# AGENDA

## DHCD WORKGROUP TWO (WG2) MEETING 2015 Code Change Cycle

July 20, 2016 at 9:30 a.m.

# C-103.3(2) cdpVA-15

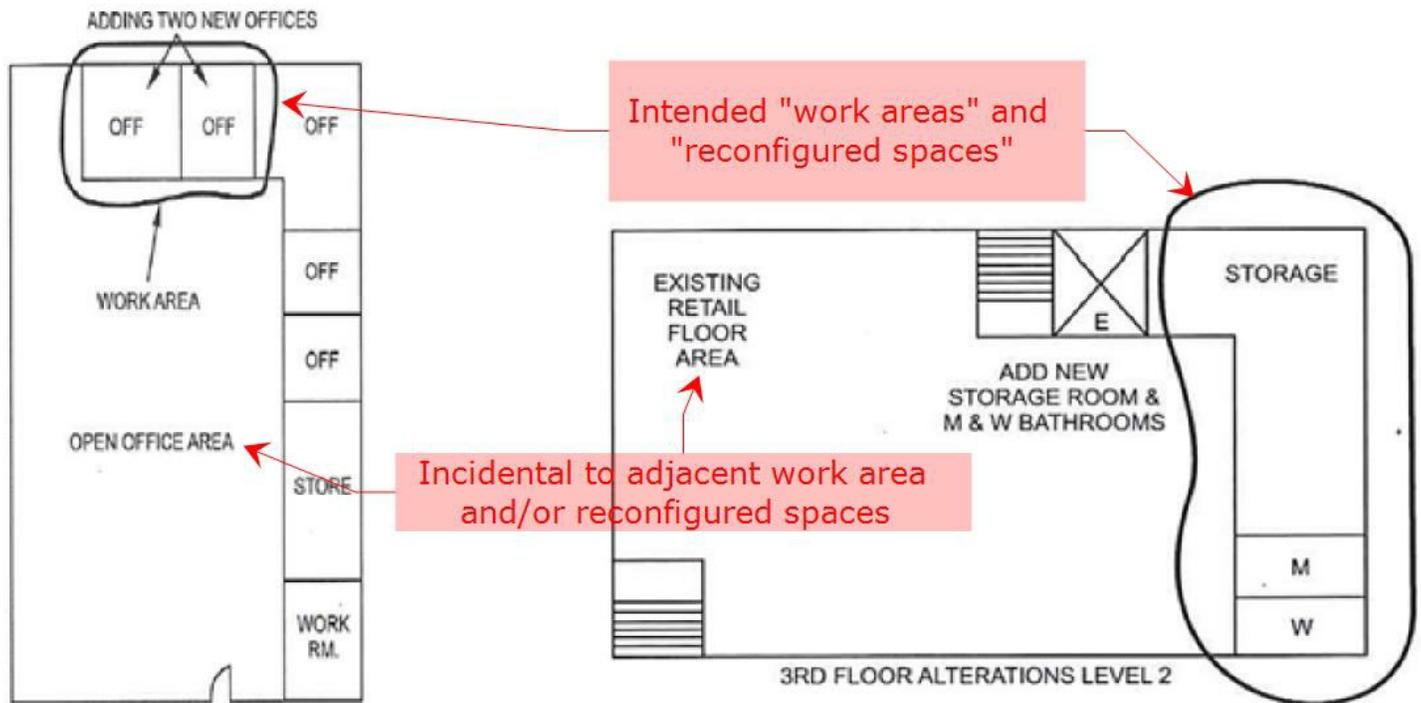
3. Since the term "reconfigured space" is not defined, this is usually the basis upon which inconsistent interpretations are made. Under the scenarios above, some code officials have interpreted adjacent spaces were incidental and not part of the *intended* work, but those spaces were nonetheless reconfigured, so they required them to be included in the *work area*.

We either need a definition of "reconfigured space" as difficult as that may be, or delete the term entirely and incorporate that "concept" into the *work area* definition. The new "work area" definition in this code change proposal opted for the latter approach and breaks down as follows:

### "where a wall or walls are added, relocated, or removed."

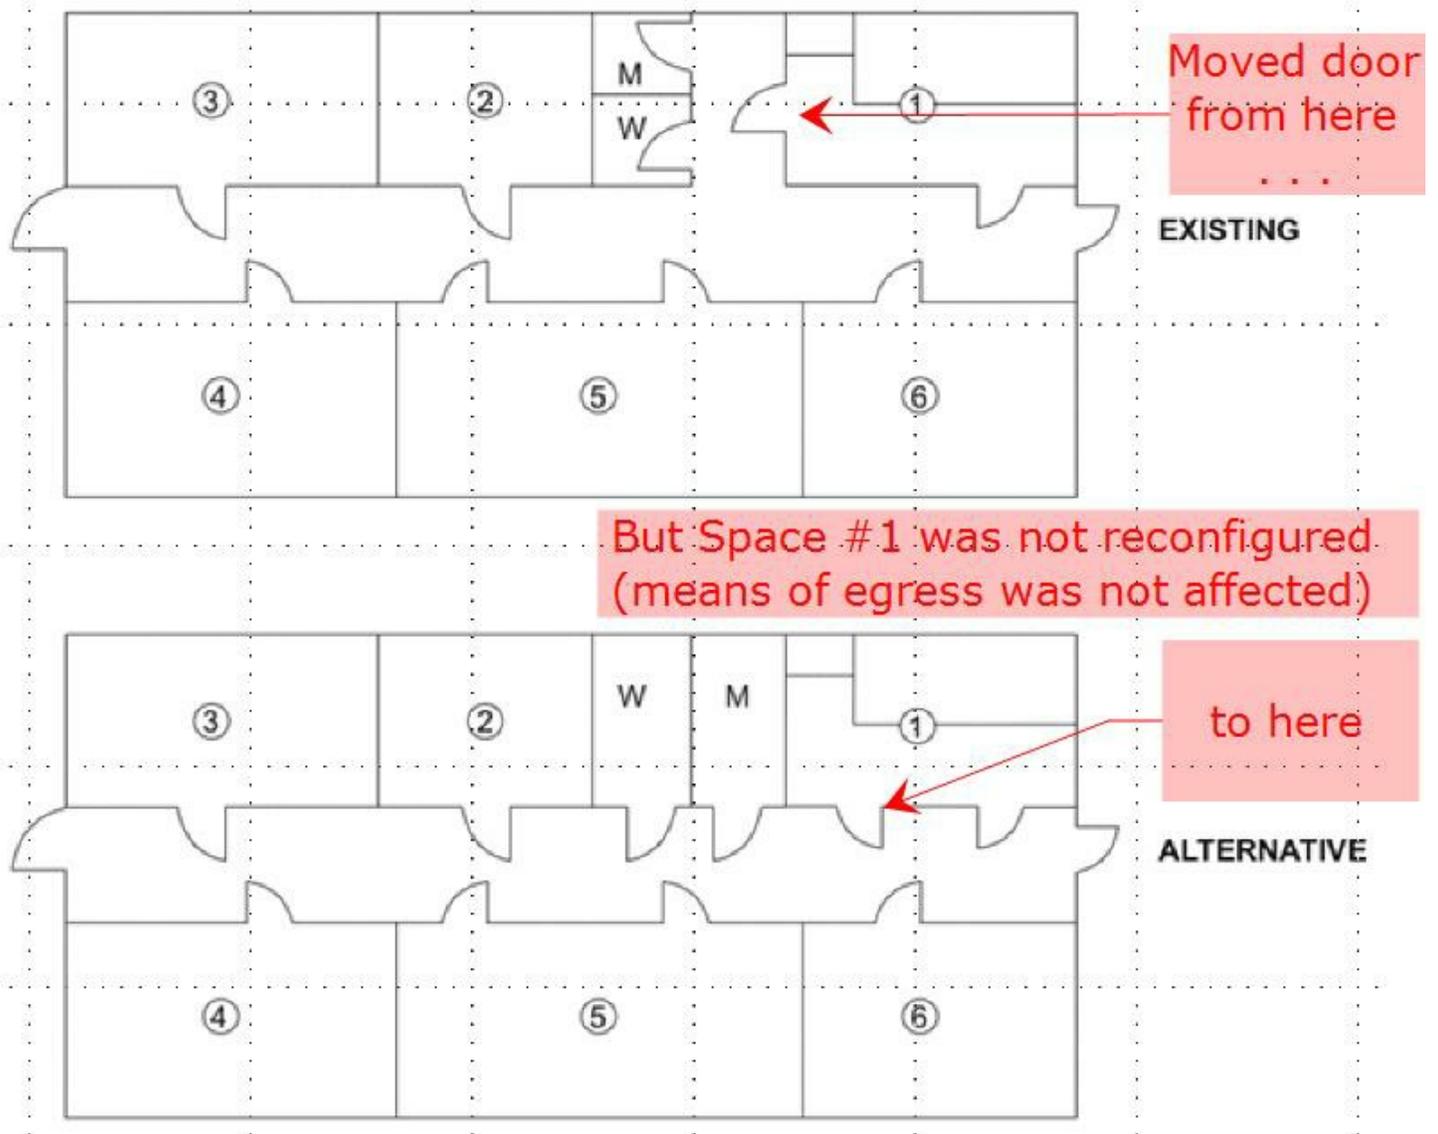
- Simply put, if the work involves the adding, relocating, or removing walls - it is a work area.
- Work not involving walls would be covered by other aspects of the VRC.
  - For example if the work did not involve walls, but would affect the means of egress, either Sections 905 or 805 would apply - if they would not apply, then you must still comply with Section 704. If the work does not maintain the level of protection, then it must be addressed.

**"the reconfiguration or extension of any system; the installation of any additional equipment;**

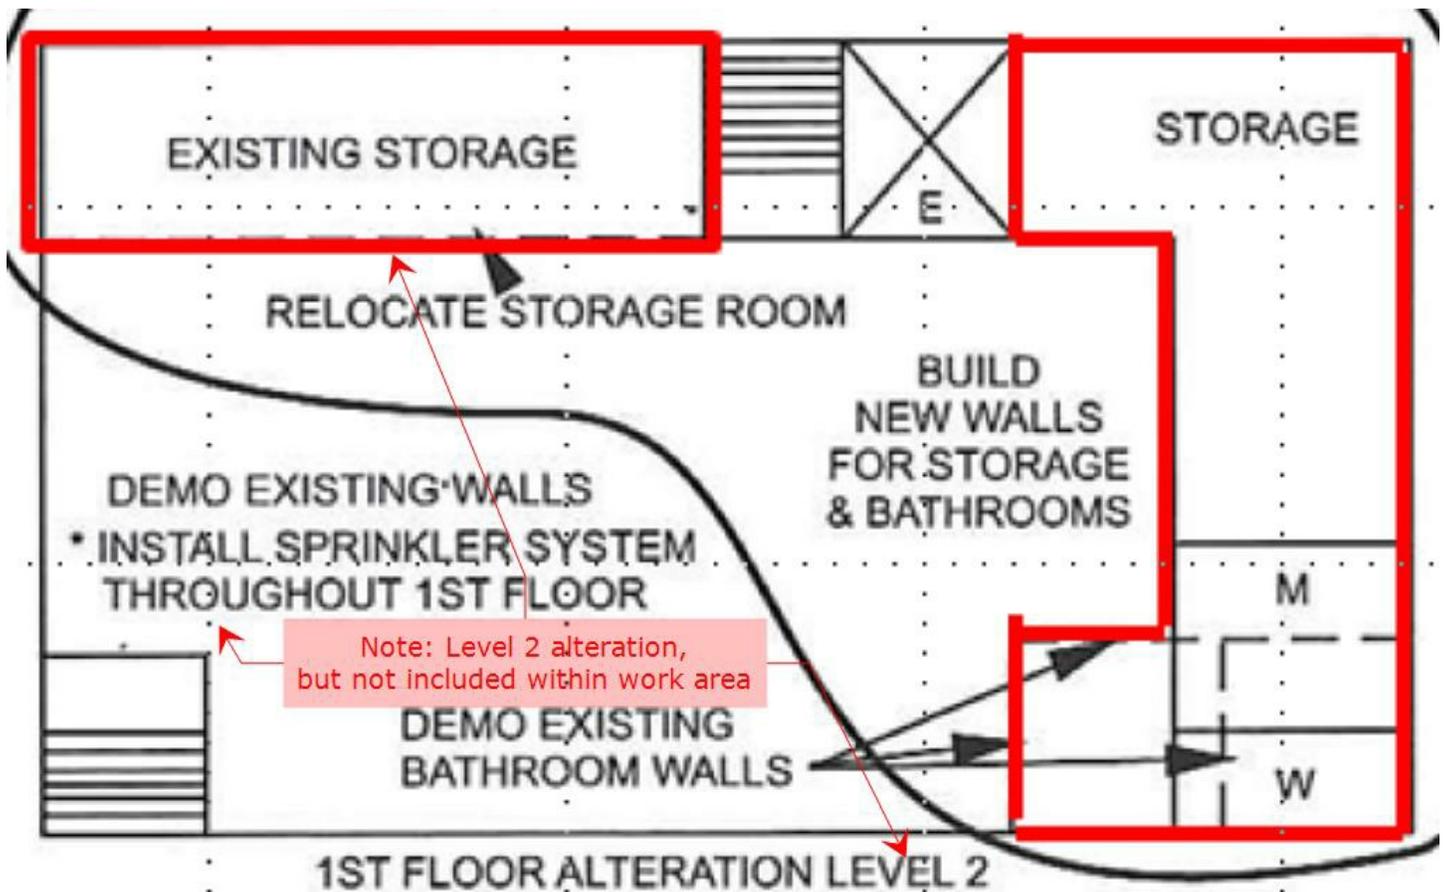
- This language comes from VRC 504.1 and clarifies that reconfiguring a "system" or just adding equipment does not constitute a reconfigured space, and therefore, would not be considered a *work area*.

- Each of those would still be considered a Level 2 alteration (per VRC 504.1), but they would not constitute a reconfigured space or *work area*.
  - For example, a new sprinkler system added would be considered a Level 2 alteration, but not a work area (refer to the diagram below).
